File N°: 06565  
Project: AP-EL-90-0061

This is in response to your recent notification given in accordance with the Electricity and Gas Inspection Regulations, Section 13, regarding devices approved under Notice of Approval E-24, E-273 and E-279. It is noted that these devices are to be modified as follows:

File N°: 06565  
Project: AP-EL-92-0089

This is in response to your recent notification given in accordance with the Electricity and Gas Inspection Regulations, Section 13, regarding devices approved under Notices of Approval E-279, AE-0352 and AE-0497. It is noted that these devices may be modified as follows:

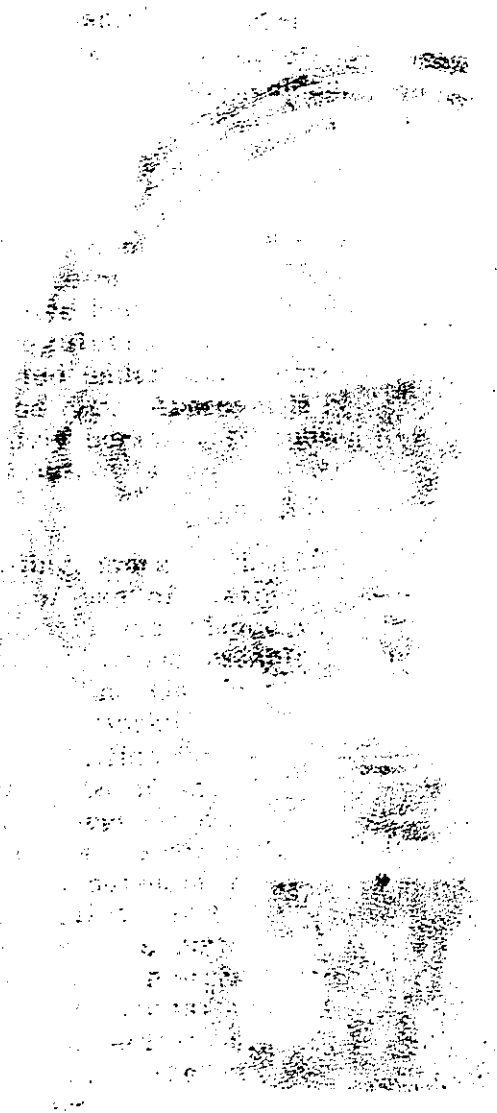
- Epoxy compound may be substituted in place of butyl material as insulation
- on meter coils of the V-60 series of polyphase meters.
- 
- 
-

I am advised by the Electrical Metrology Laboratory that their evaluation of the proposed modifications indicates that they may be regarded as immaterial in relation to the approval provisions of the Act. Accordingly, your notification is acknowledged and the modifications are accepted as being included within the above-noted approval. All recipients of the approval notice are being informed by copy of this letter.
